**Submission on RUVITL's Petition
Seeking Approval for the Procurement
of 3,200 MW of Thermal Power for 25
Years Through a Competitive Bidding
Process and for Deviations from the
Model Bidding Document**

Rajasthan Urja Vikas & IT Services Limited (RUVITL) has submitted a Petition under Section 86(1)(b) and other applicable provisions of the Electricity Act, 2003, before the Rajasthan Electricity Regulatory Commission (RERC), seeking approval for the procurement of 3,200 MW (4×800 MW) of power for 25 years through a competitive bidding process. The procurement is based on the Model Bidding Documents issued under the Ministry of Power (MoP), Government of India (GoI) Guidelines dated 06.03.2019 for the procurement of electricity from thermal power stations to be set up on a Design, Build, Finance, Own, and Operate basis, with fuel sourcing. Under the Petition, RUVITL has also sought approval for proposed deviations/amendments to the Model Bidding Documents.

Figure 1: Actual demand in Rajasthan against projections of 17th to 19th EPS

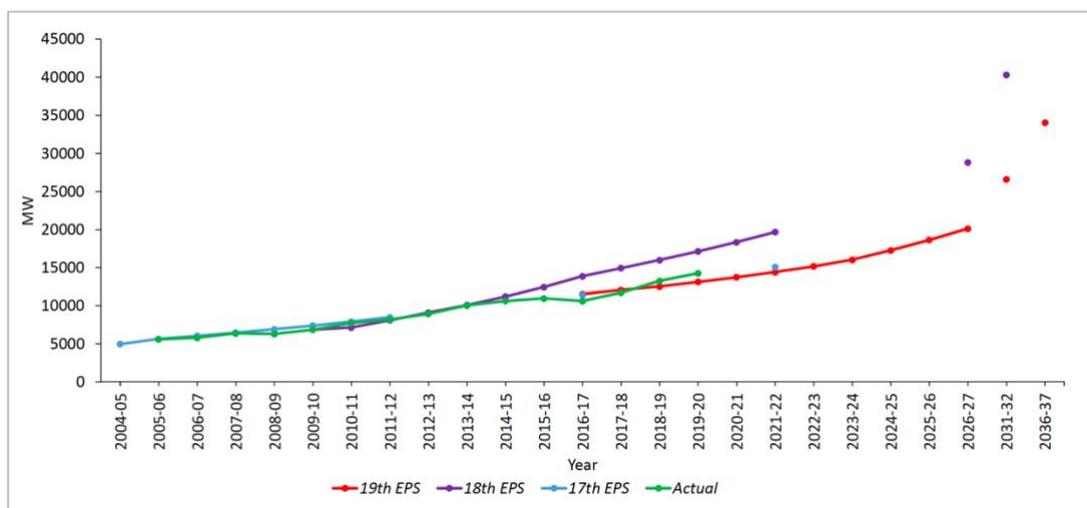
In addition, it is important to note that the CEA projections in the 18th Electric Power Survey (EPS) significantly deviated from the actual demand in Rajasthan, resulting in over-investment in generation in the past (*see Figure 1*). Therefore, it is essential for the State Discoms to conduct long-term demand forecasting using appropriate methods and their own data, while also considering CEA estimates. This approach will help minimize deviations from actual demand and ensure prudent capacity planning.
